File: 01-MEN-1-43.3/44.1
01-401101
Albion River Br. #10-0136
Bridge Replacement

Subject: Advance Planning Study Pricing Update

Attached is the Advance Planning Study pricing update for the Albion River Bridge replacement alternatives that were studied in 2009 (see the APS Transmittal memo from Jeff Sims to Ilene Poindexter dated April 27, 2009).

DESIGNED BY Daniel Sessions	DATE 12/30/08	STRUCTURE DESIGN BRANCH 1	ALTERNATIVE 1A
DRAWN BY Bob Huddleston	DATE 12/30/08		PLANNING STUDY
CHECKED BY Kevin Harper	DATE 2/4/09		ALBION RIVER BR (REPLACE)
APPROVED Jeff Sims	DATE 2/4/09		BRIDGE NO. 10-136 / CU 01 / SCALE: AS SHOWN / EA 40110K

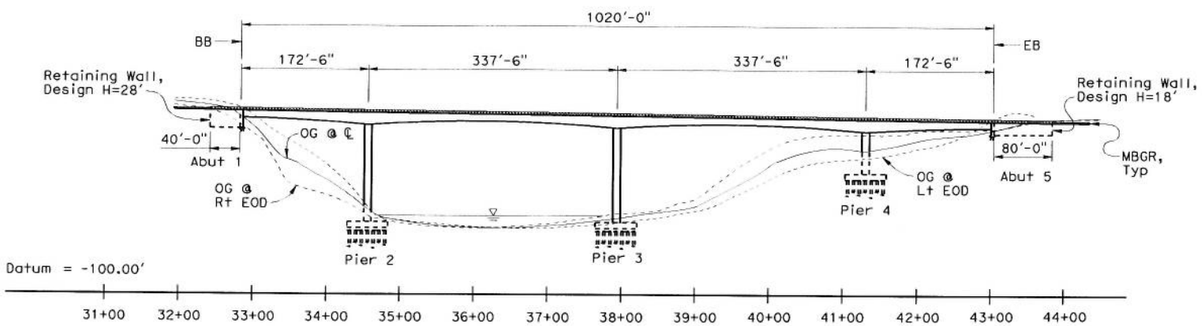
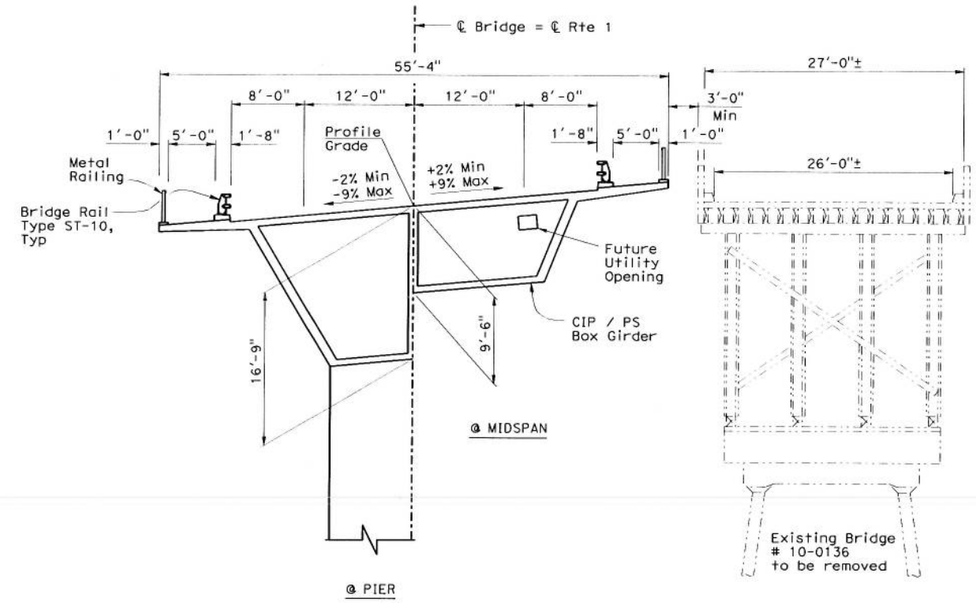
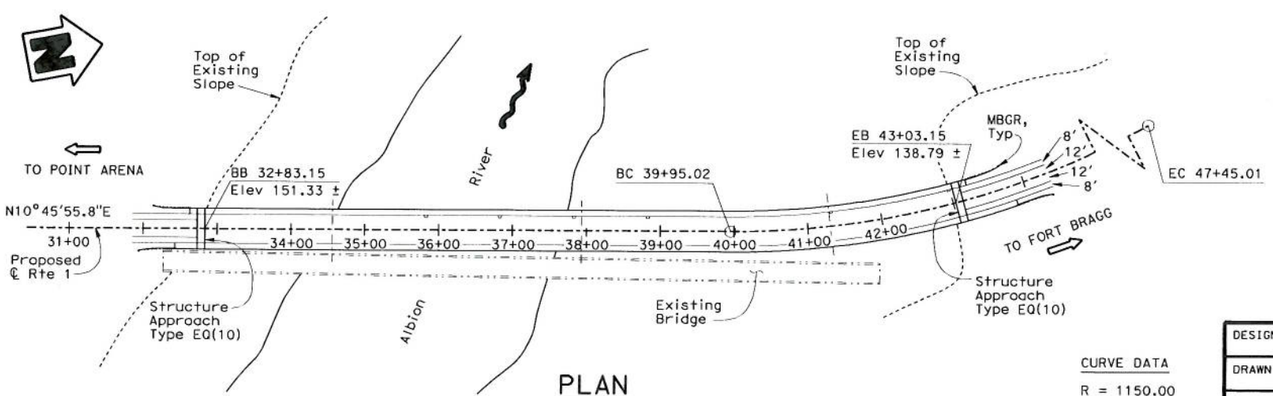
Date of Estimate	~~4-27-09~~ 5-17-13
Str. Depth	= Varies
Length	= 1020 ft
Width	= 55'-4"
Area	= 56,440 ft²
Cost/sq ft including 10% Mobilization & 25% Contingency	= ~~$545/sq ft~~ $515/sq ft
Total Cost	= ~~$30,747,400~~ $29,058,000

ALTERNATIVE 1B

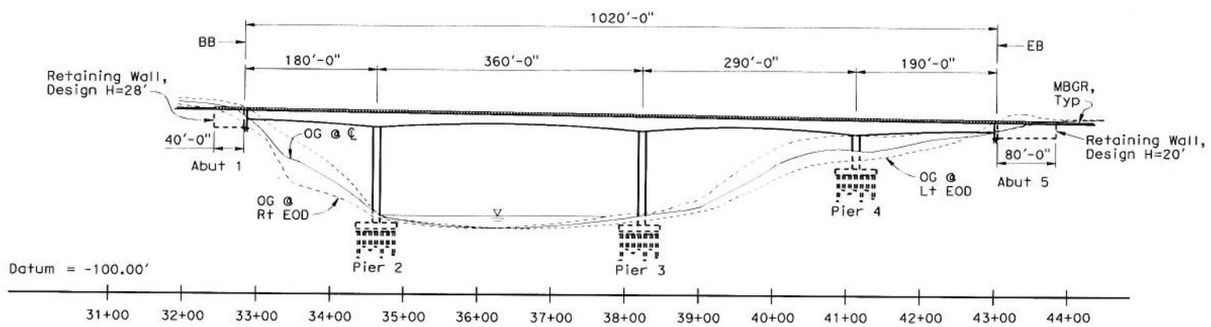
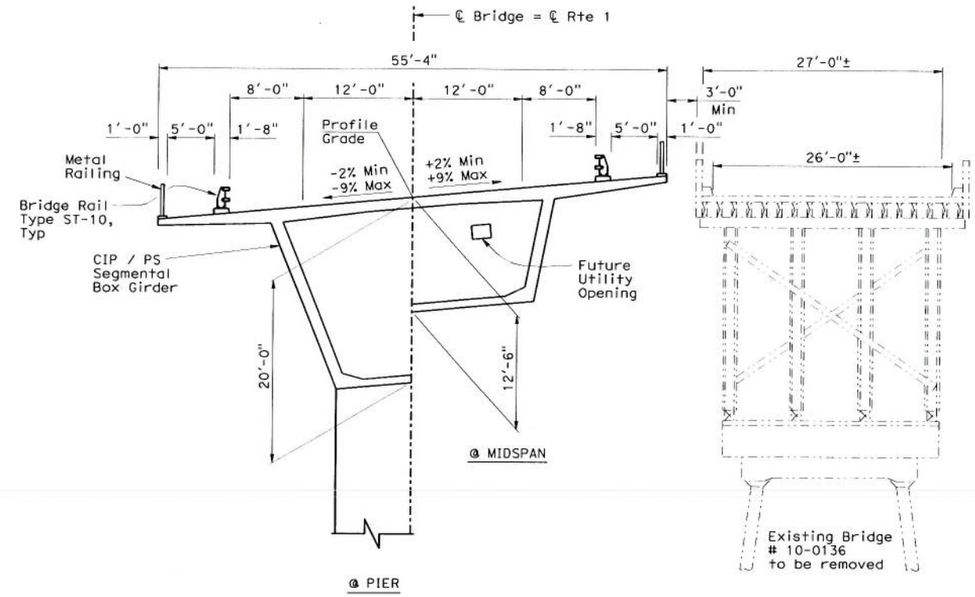
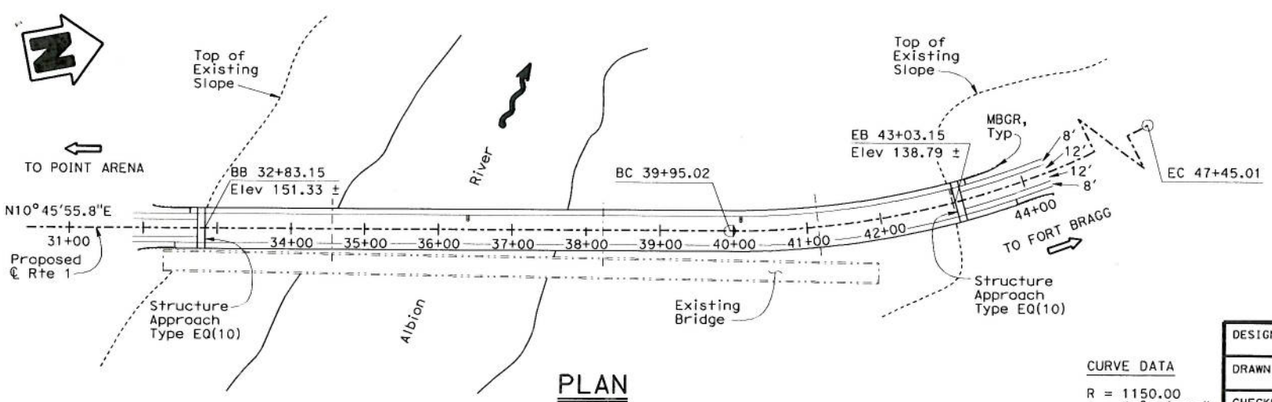
Date of Estimate	~~4-27-09~~ 5-17-13
Str. Depth	Varies
Length	1020 ft
Width	55'-4"
Area	56,440 ft²
Cost/sq ft including	
10% Mobilization &	~~$788/sq ft~~ $808/sq ft
25% Contingency	~~$44,456,200~~ $45,629,000
Total Cost

DESIGNED BY Daniel Sessions	DATE 12/30/08	STRUCTURE DESIGN BRANCH 1	ALTERNATIVE 1C
DRAWN BY Bob Huddleston	DATE 1/7/09		PLANNING STUDY
CHECKED BY Kevin Harper	DATE 2/4/09		ALBION RIVER BR (REPLACE)
APPROVED Jeff Sims	DATE 2/4/09		BRIDGE NO. 10-136 / CU 01
			SCALE: AS SHOWN / EA 40110K

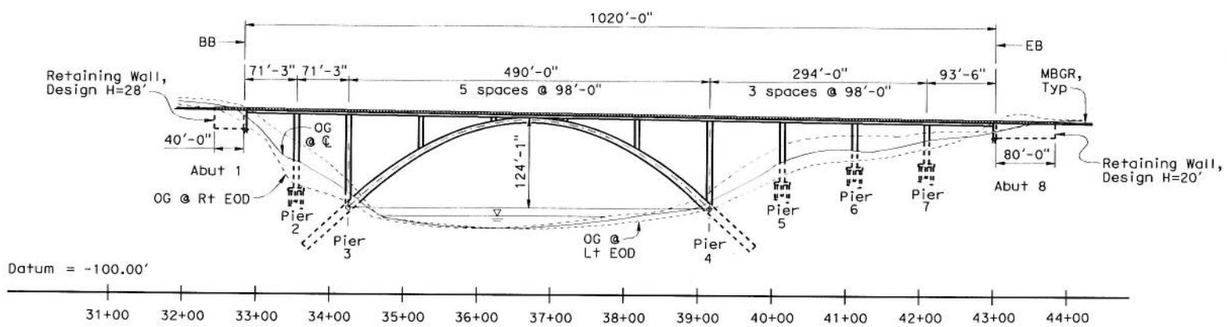
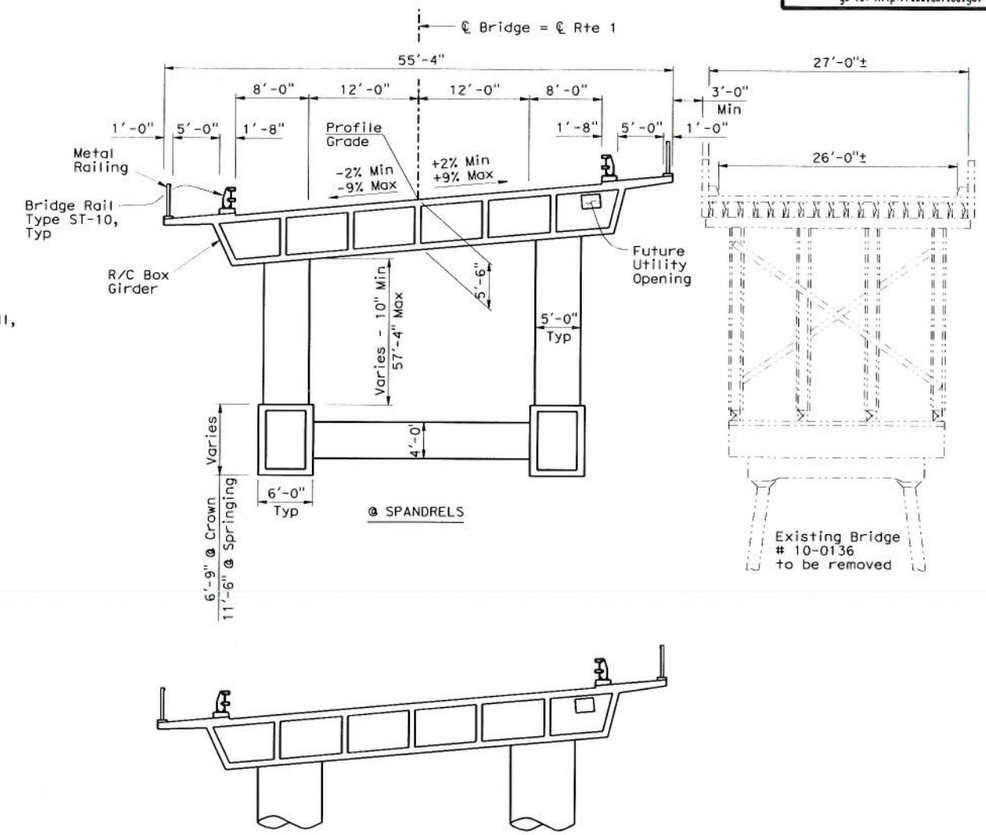
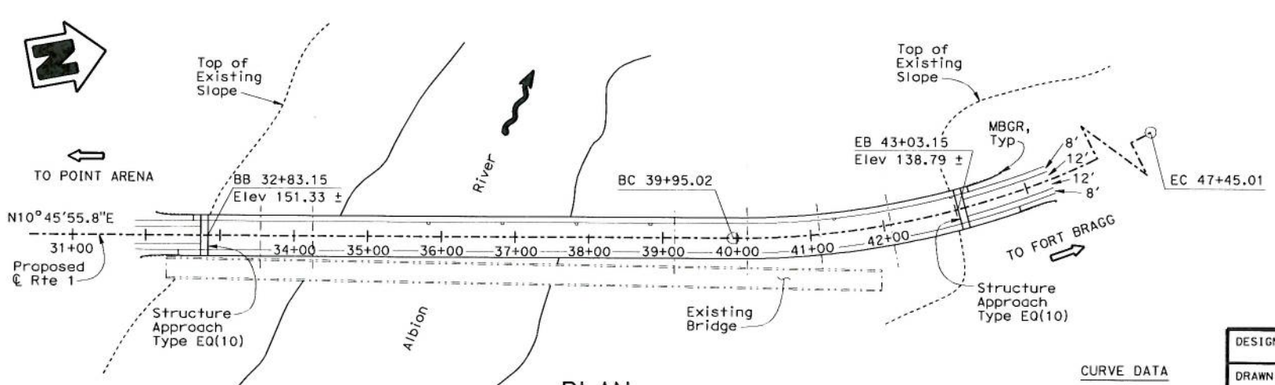
Date of Estimate	~~4-27-09~~ 5-17-13
Str. Depth	= Box = 5.5 ft, Arch = 6.75 to 11.5 ft
Length	= 1020 ft
Width	= 55'-4"
Area	= 56,440 ft²
Cost/sq ft including 10% Mobilization & 25% Contingency	$451/sq ft ~~$459/sq ft~~
Total Cost	= ~~$25,914,800~~ $25,463,000

ALTERNATIVE 1D

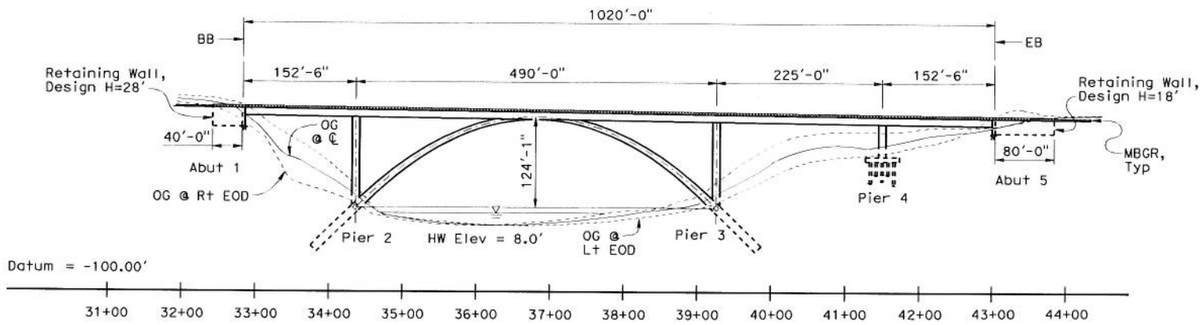
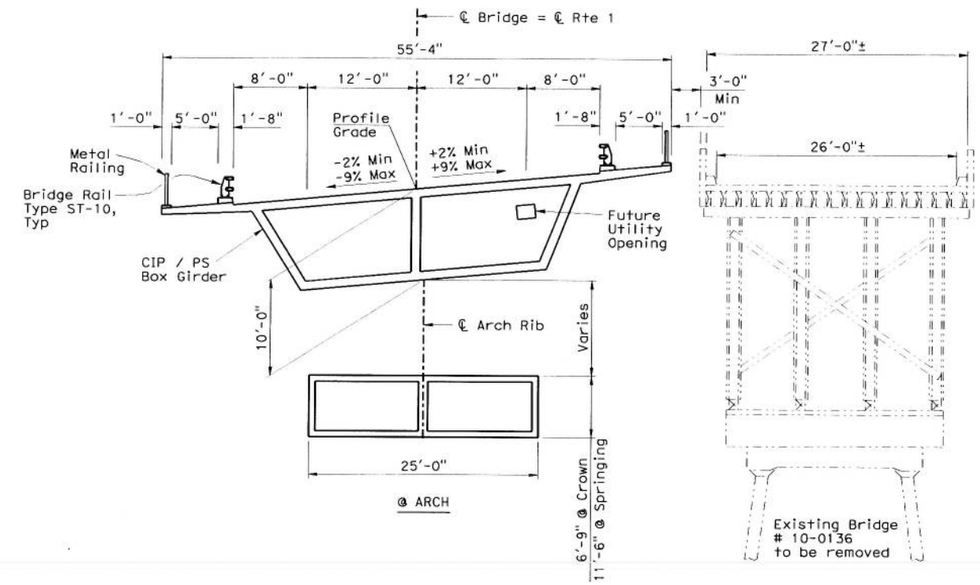
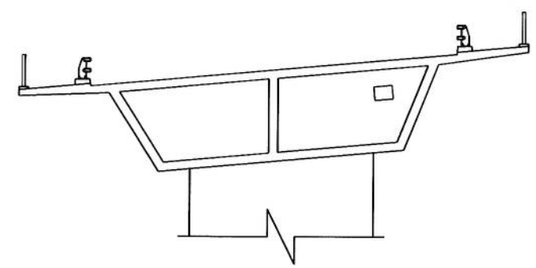
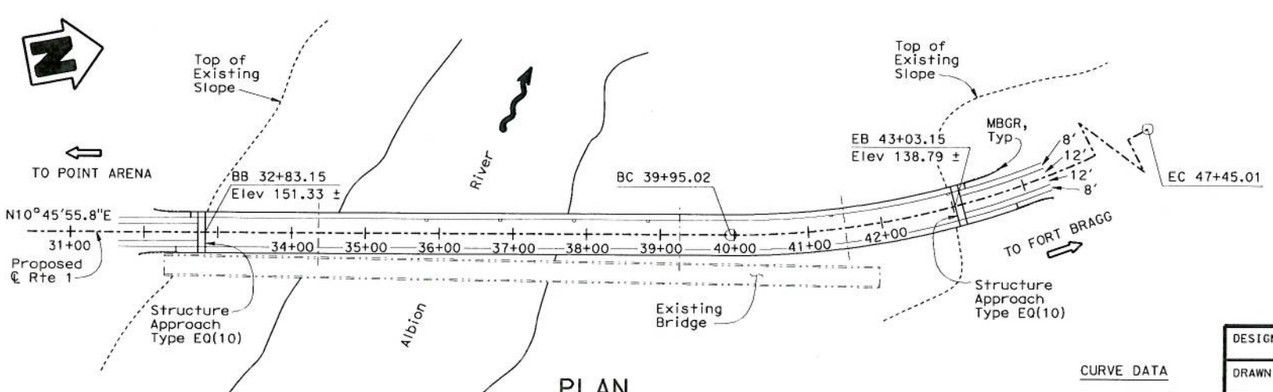
Date of Estimate	~~4-27-09~~ 5-17-13
Str. Depth	Box = 10.0 ft, Arch = 6.75 to 11.5 ft
Length	1020 ft
Width	55'-4"
Area	56,440 ft²
Cost/sq ft including 10% Mobilization & 25% Contingency	~~$591/sq ft~~ $588/sq ft.
Total Cost	~~$32,372,400~~ $33,172,000

ALTERNATIVE 2A

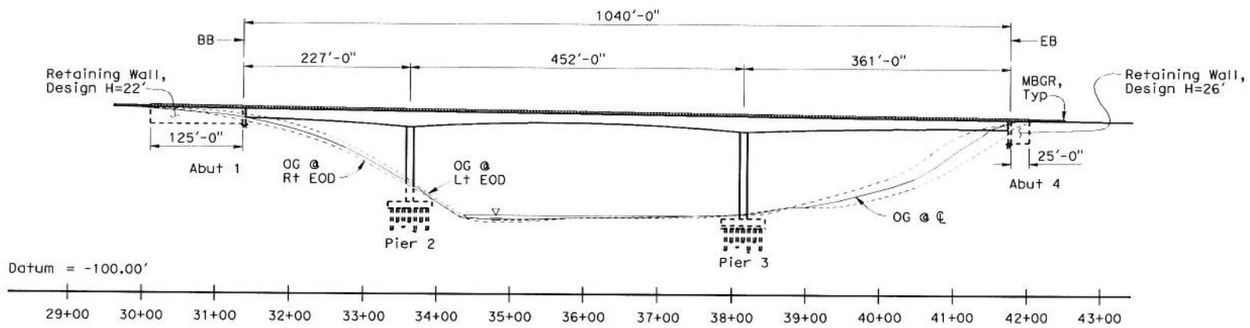
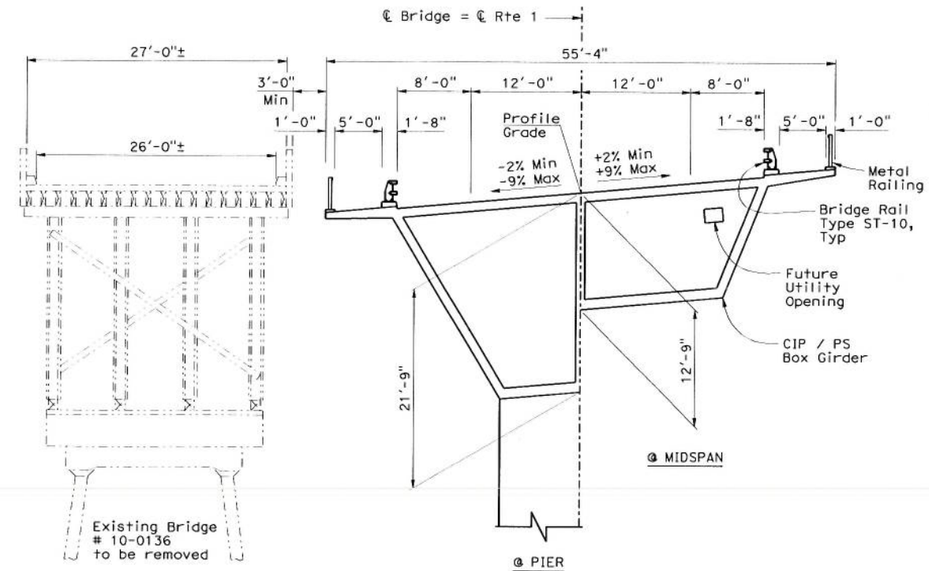
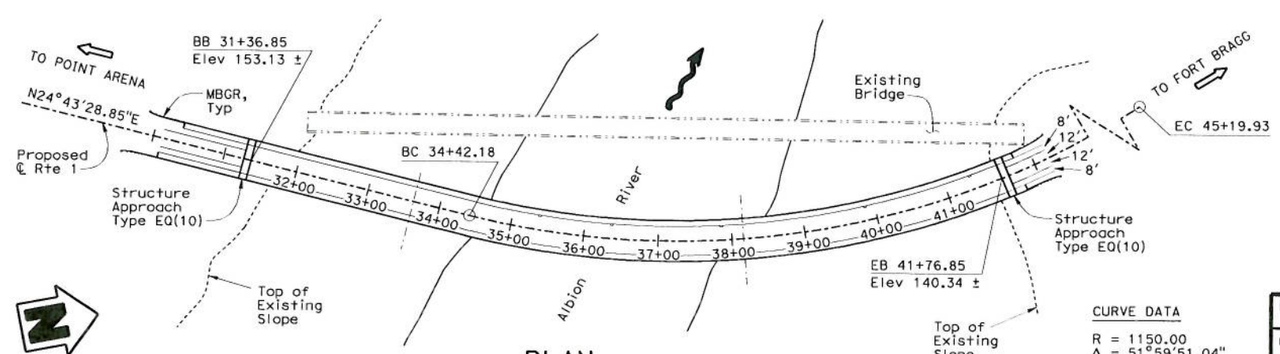
Date of Estimate	~~4-27-09~~ 5-17-13
Str. Depth	Varies
Length	1040 ft
Width	55'-4"
Area	57,547 ft²
Cost/sq ft including	
10% Mobilization &	
25% Contingency	~~$458/sq ft~~ $484/sq ft.
Total Cost	~~$26,378,000~~ $27,869,000

DESIGNED BY Daniel Sessions	DATE 12/30/08	STRUCTURE DESIGN BRANCH 1	ALTERNATIVE 2B
DRAWN BY Bob Huddleston	DATE 1/26/09		PLANNING STUDY
CHECKED BY Kevin Harper	DATE 2/4/09		ALBION RIVER BR (REPLACE)
APPROVED Jeff Sims	DATE 2/4/09		BRIDGE NO. 10-136 / CU 01
			SCALE: AS SHOWN / EA 40110K

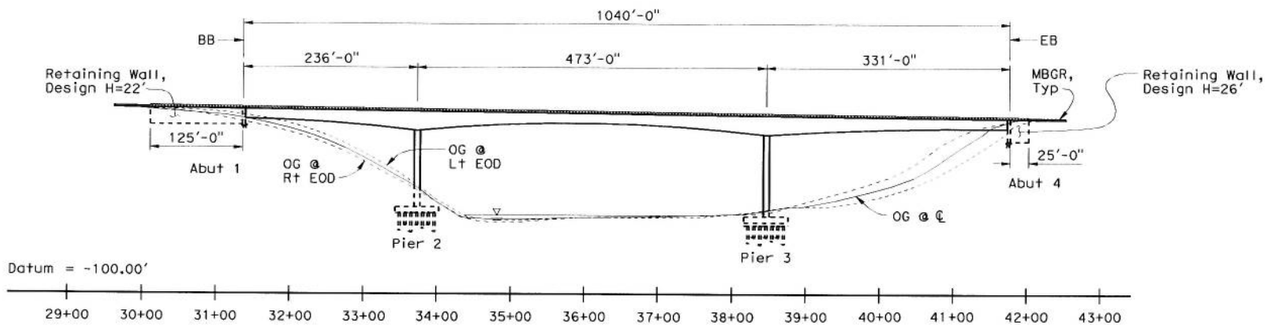
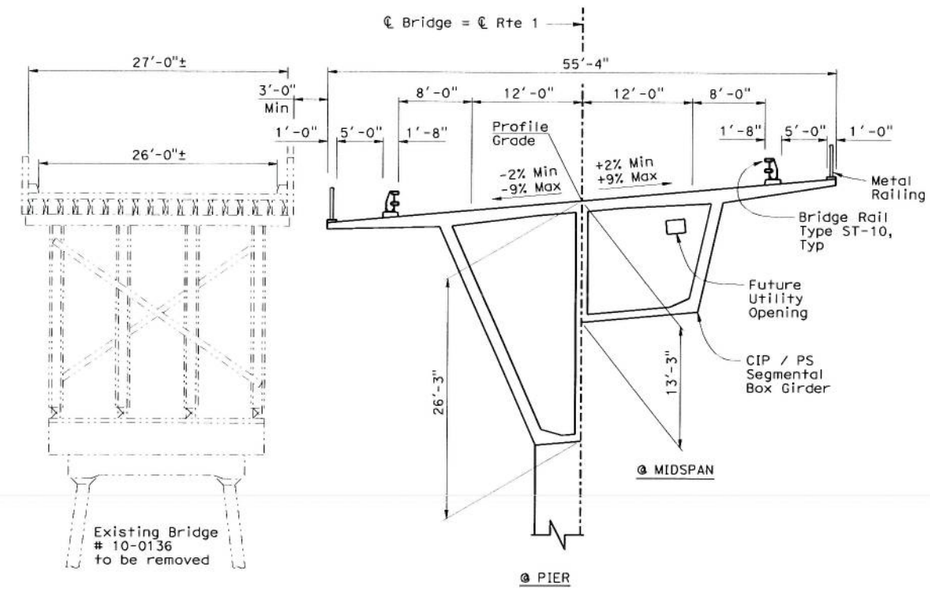
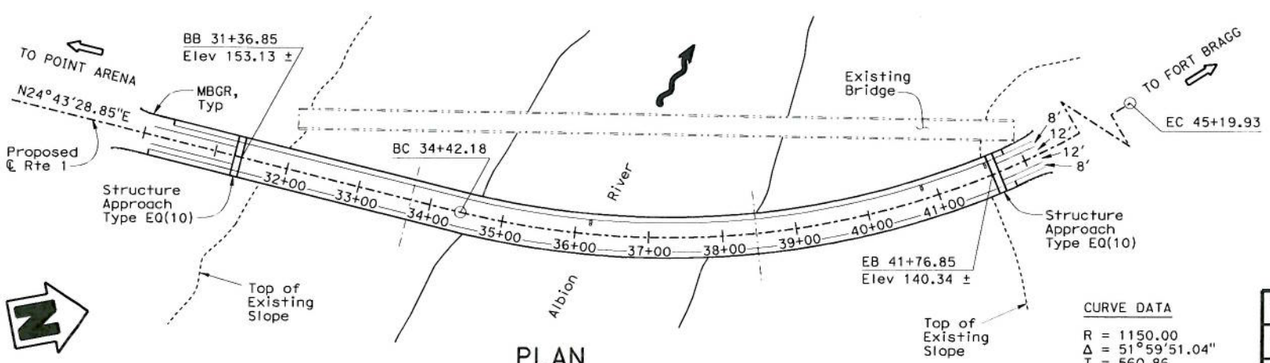
Date of Estimate	~~4-27-09~~ 5-17-13
Str. Depth	= Varies
Length	= 1040 ft
Width	= 55'-4"
Area	= 57,546 ft²
Cost/sq ft including 10% Mobilization & 25% Contingency	= ~~$714/sq ft~~ $760/sq ft.
Total Cost	= ~~$41,060,900~~ $43,727,000

DESIGNED BY Kevin Harper	DATE 03/10/09	STRUCTURE DESIGN BRANCH 1	ALTERNATIVE 3A
DRAWN BY Jie Tang	DATE 03/10/09		PLANNING STUDY
CHECKED BY	DATE		ALBION RIVER BR (REPLACE)
APPROVED Jeff Sims	DATE		BRIDGE NO. 10-136 / CU 01
			SCALE: AS SHOWN / EA 40110K

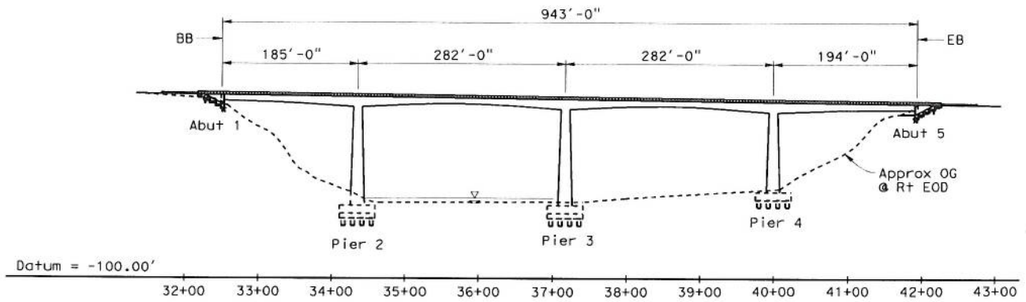
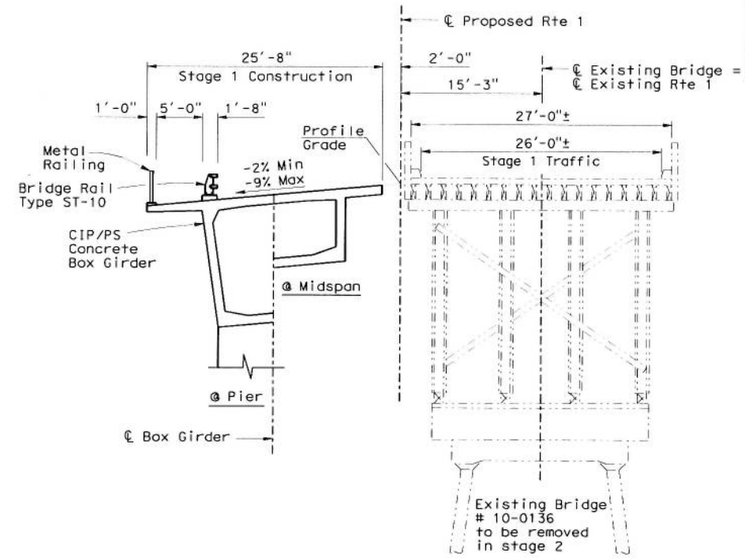
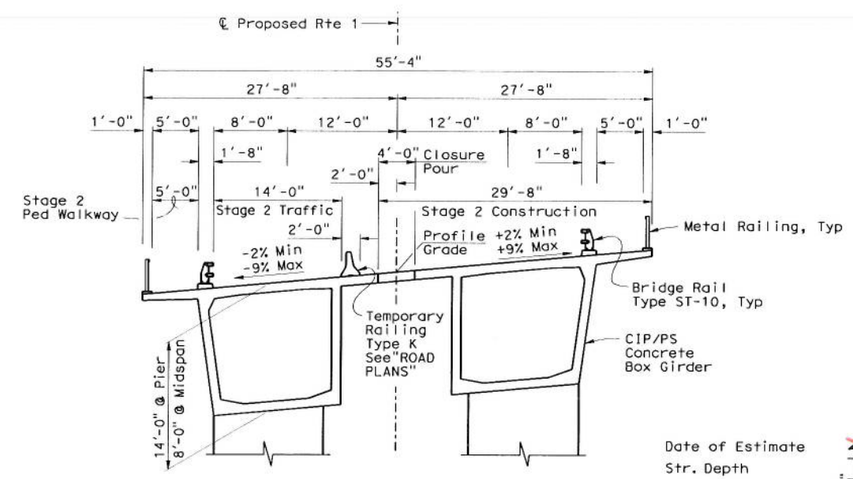
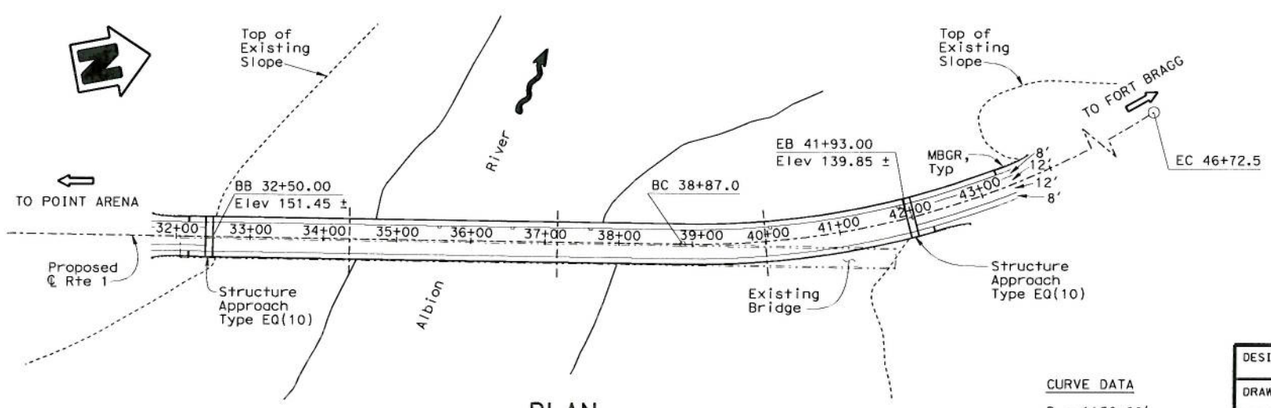
Date of Estimate	~~4-27-09~~ 5-17-13
Str. Depth	Varies
Length	943.00 ft
Width	55'-4"
Area	52,179 ft²
Cost/sq ft including	~~$ 676/sq ft~~
10% Mobilization &	~~$ 774/sq ft~~
25% Contingency	
Total Cost	~~$ 40,371,700~~ $ 35,272,000
